SITE DEVELOPMENT PLAN, AMENDMENT NO. 1

THE BRINKERHOFF & BAR HUMMINGBIRD

SITE DEVELOPMENT PLAN, AMENDMENT NO. 1
THE BRINKERHOFF & BAR HUMMINGBIRD
TOWN OF CASTLE ROCK PROJECT NO. SDP25-0007

CHANGES FROM APPROVED SDP
AMENDMENT #1

SITE DEVELOPMENT PLAN
JOB NO. BR21318
SUBM. DATE 5/21/25
DWN: TJS CHD: TWS
NAME
SITE PLAN
NO.

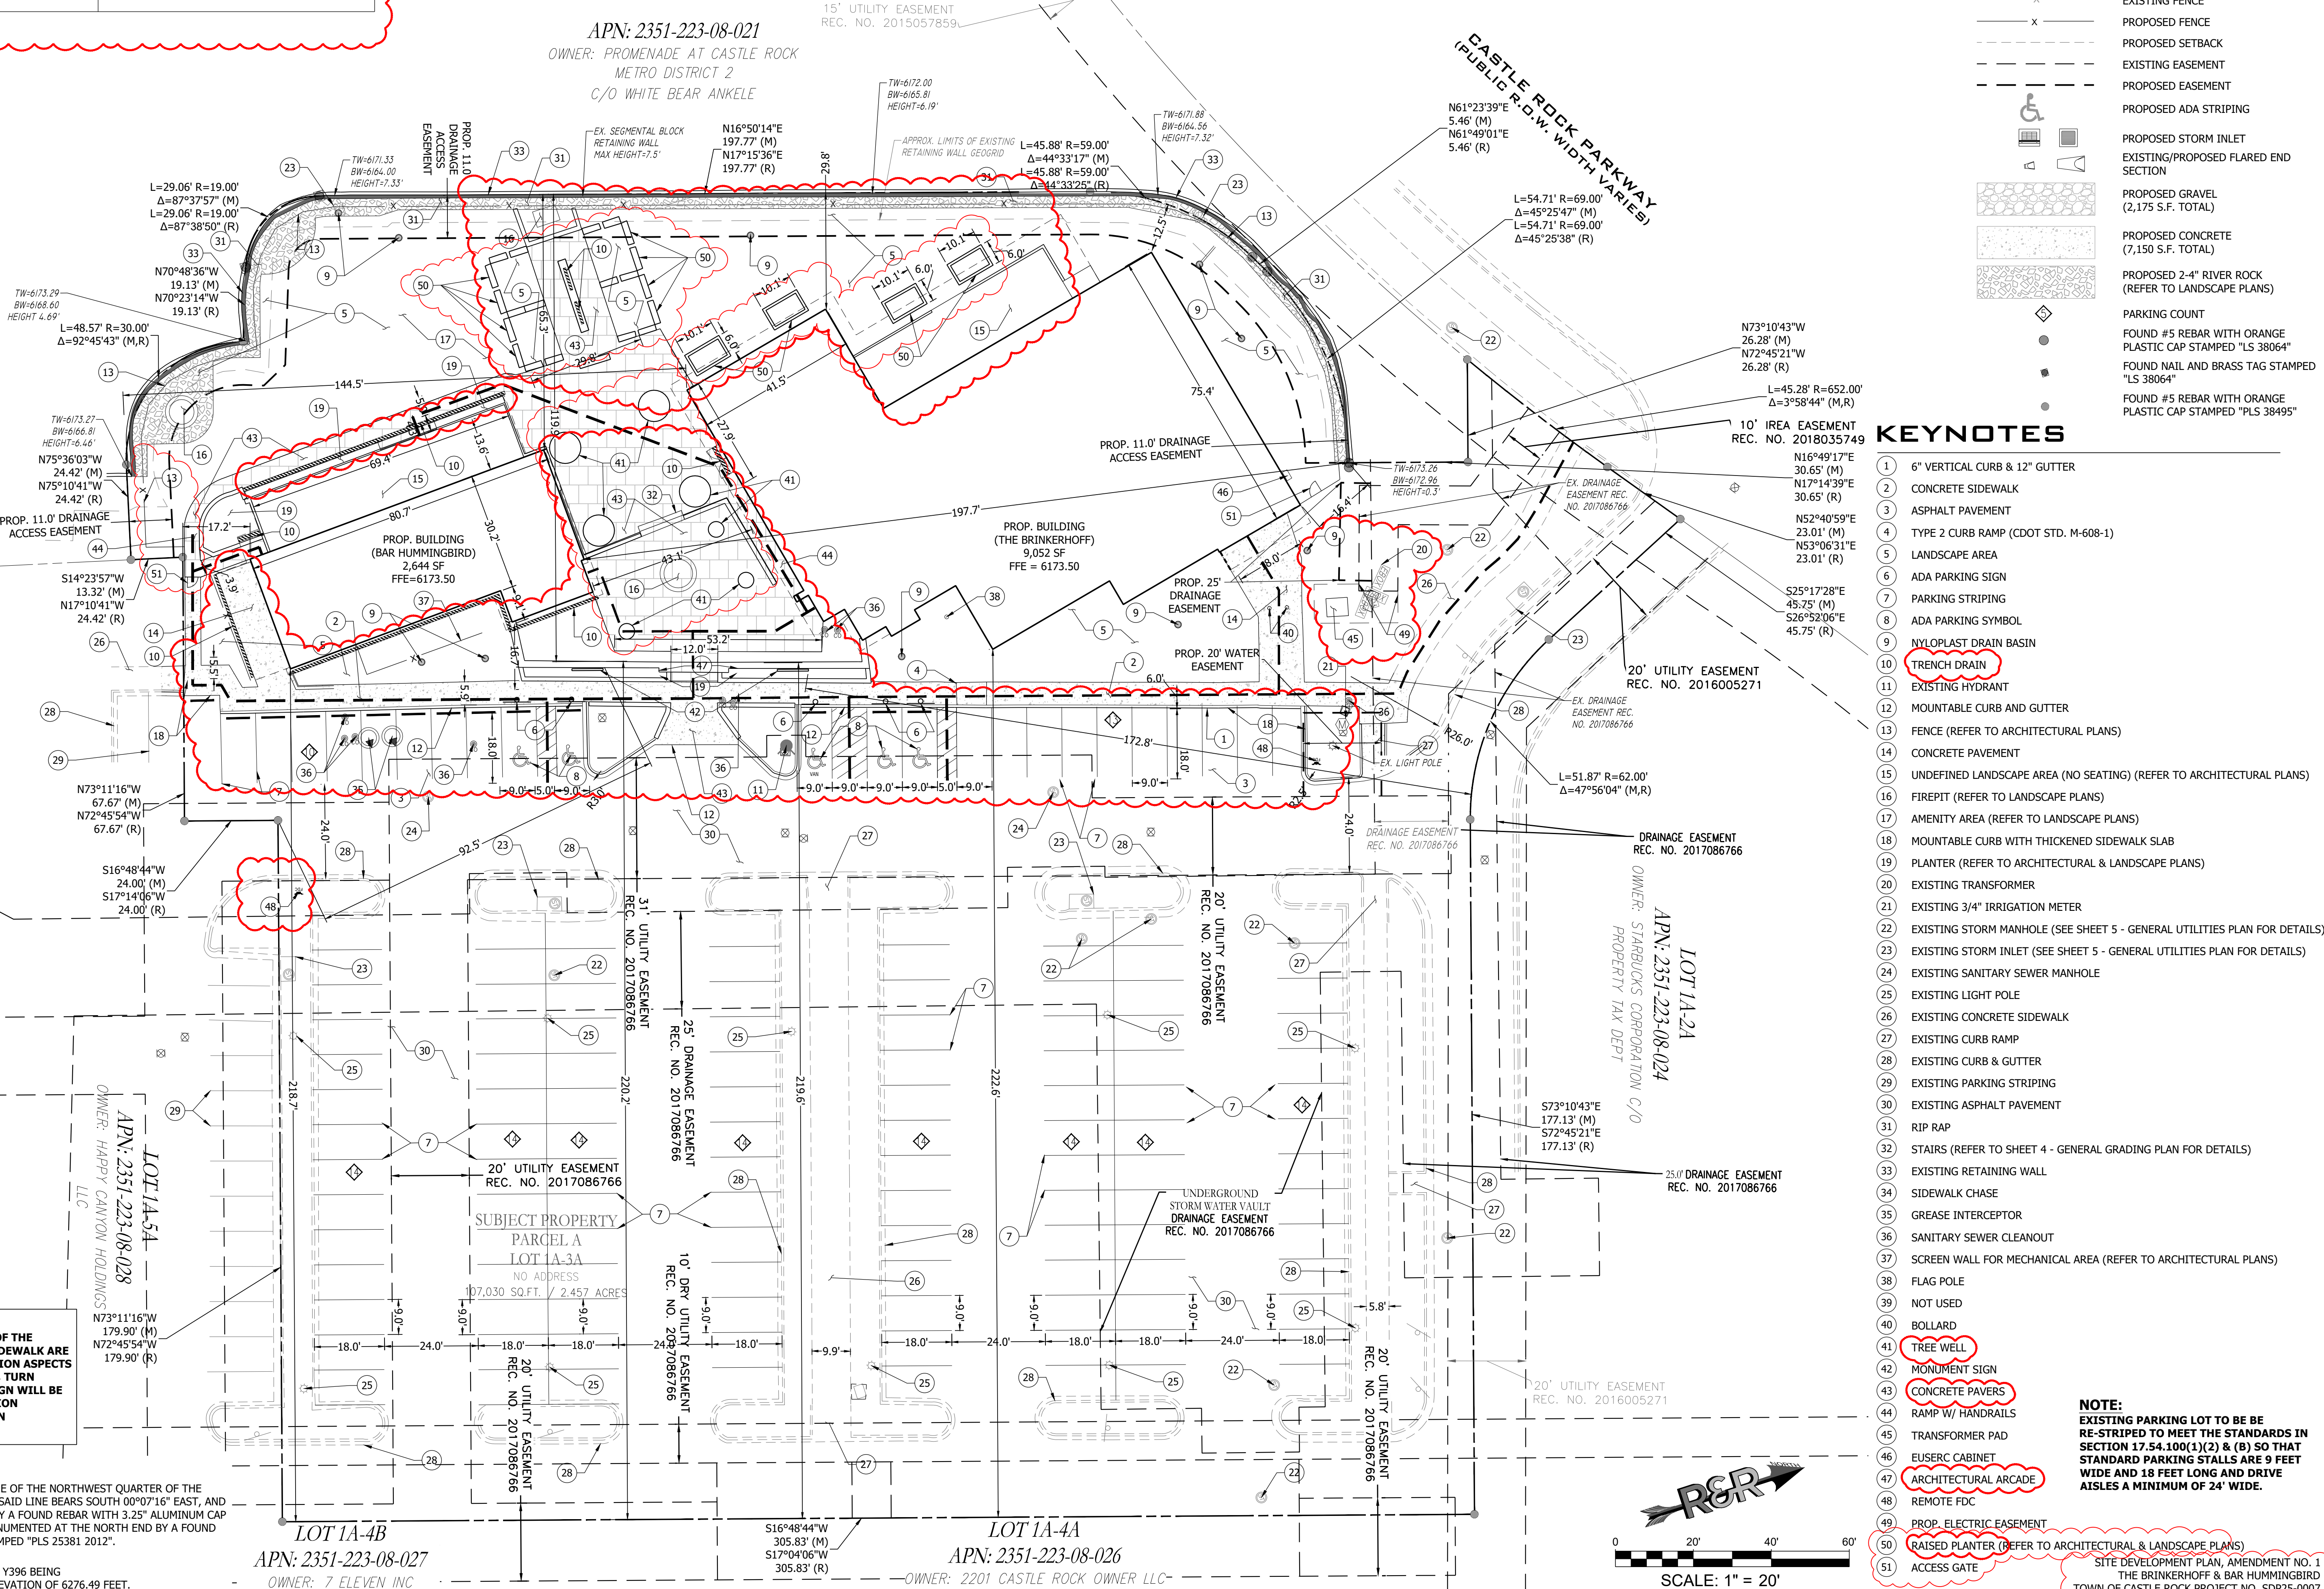
DESCRIPTION	REASONING
CALL OUTS ADDED TO PLANS WHERE REQUESTED	RAISED PLANTER CALLOUTS MISSING FROM SITE PLAN. DETAILS FOR RAISED PLANTERS TO BE PROVIDED BY LANDSCAPING & ARCHITECTURE
ACCESS GATE AND ASSOCIATED CALL OUT ADDED TO PLANS	GATE PROVIDE TO ALLOW ACCESS TO EUSERC CABINET

GENERAL UTILITIES PLAN

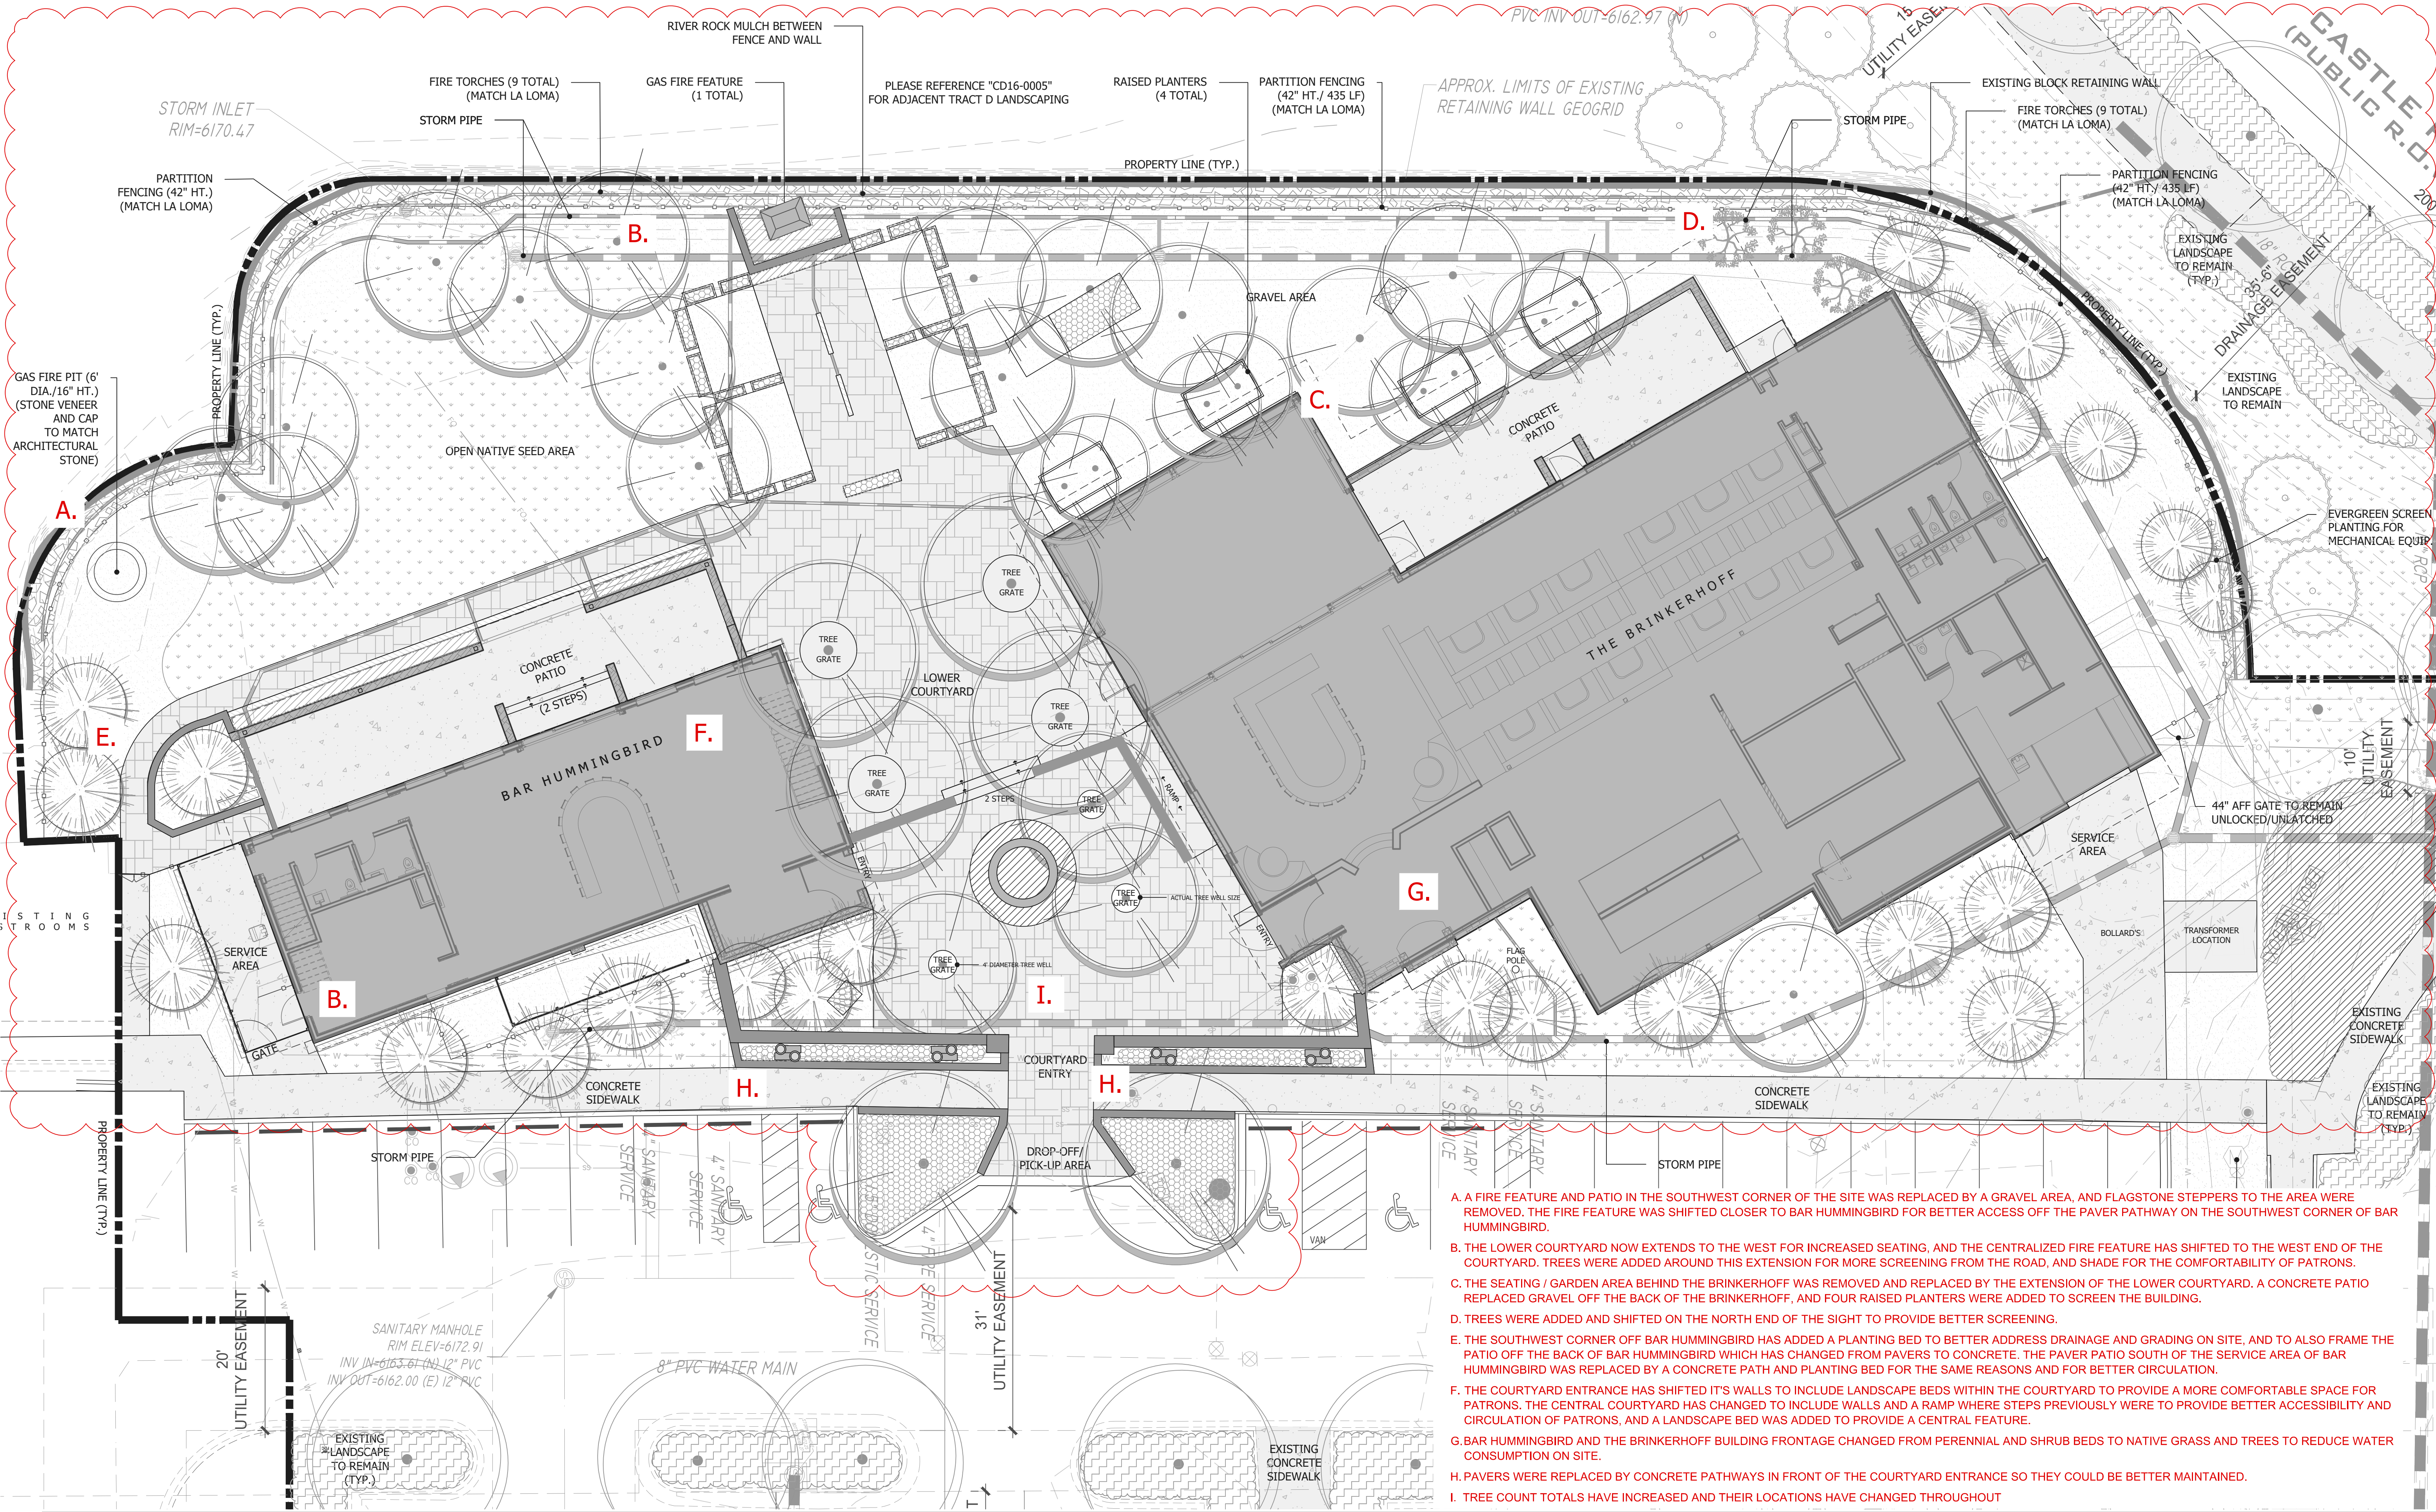
DESCRIPTION	REASONING
SANITARY AND WATER LINE ALIGNMENTS SHIFTED	WATER LINES SHIFTED TO MATCH CONTRACTOR'S NOTES ON INSTALL LOCATIONS.

GAS FIRE FEATURE

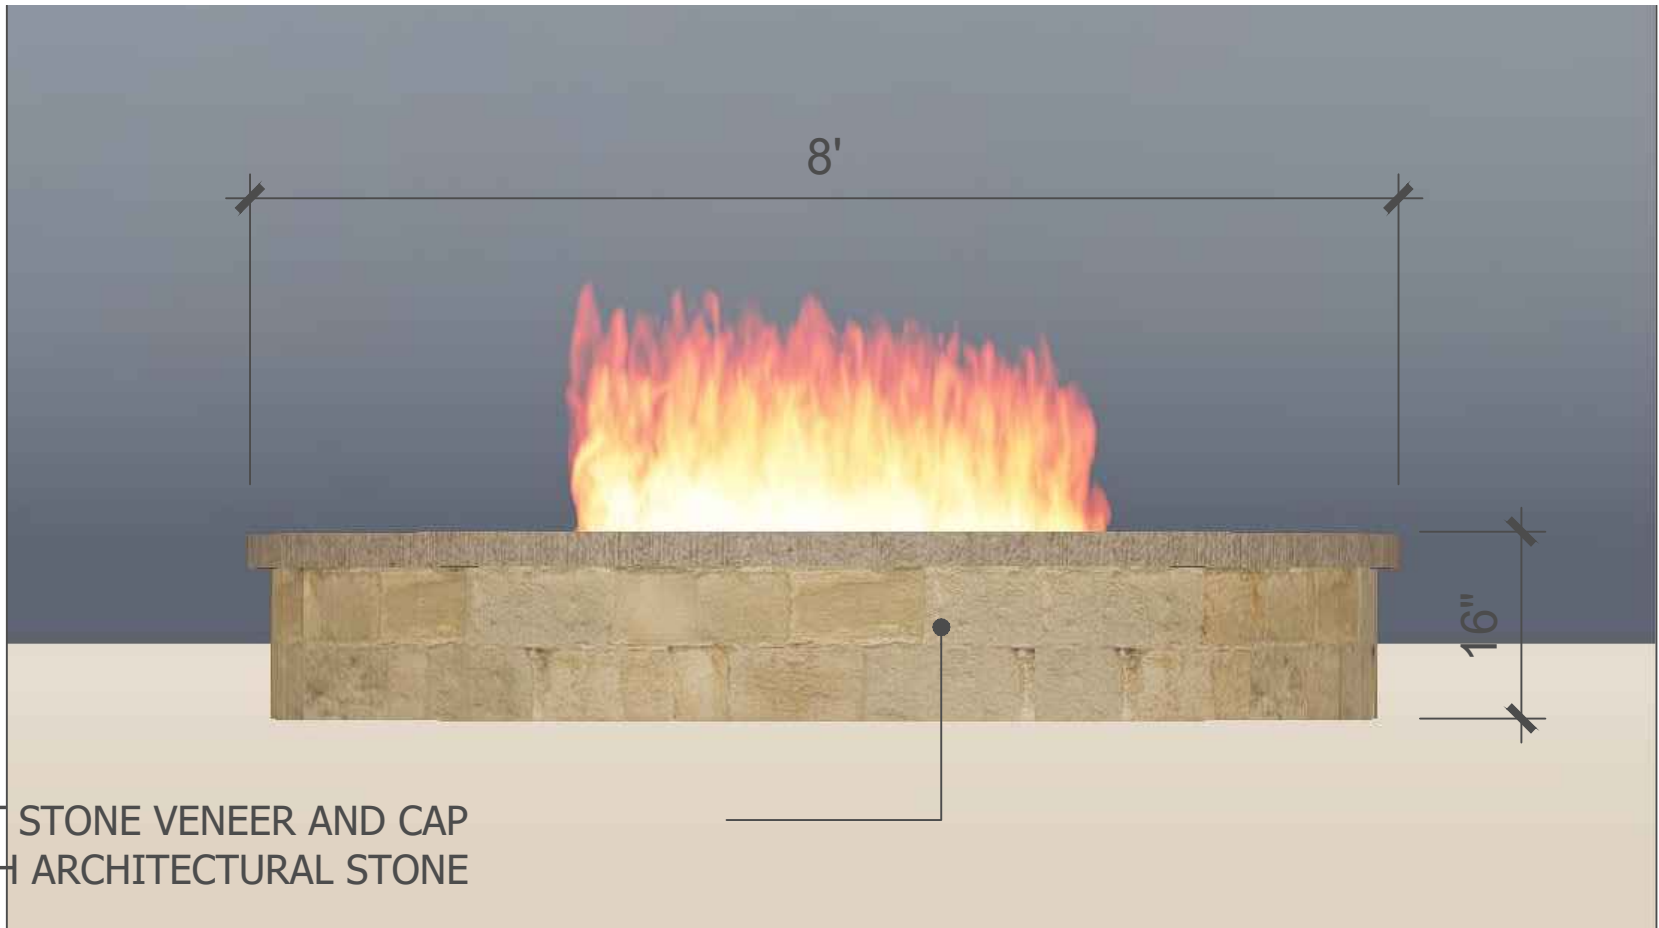
THE FIRE FEATURE WAS UPDATED TO ALIGN WITH THE EXISTING STEEL TORCHES AND THE OVERALL DESIGN AESTHETIC OF THE PROJECT ON THE WEST EDGE OF THE LOWER COURTYARD.
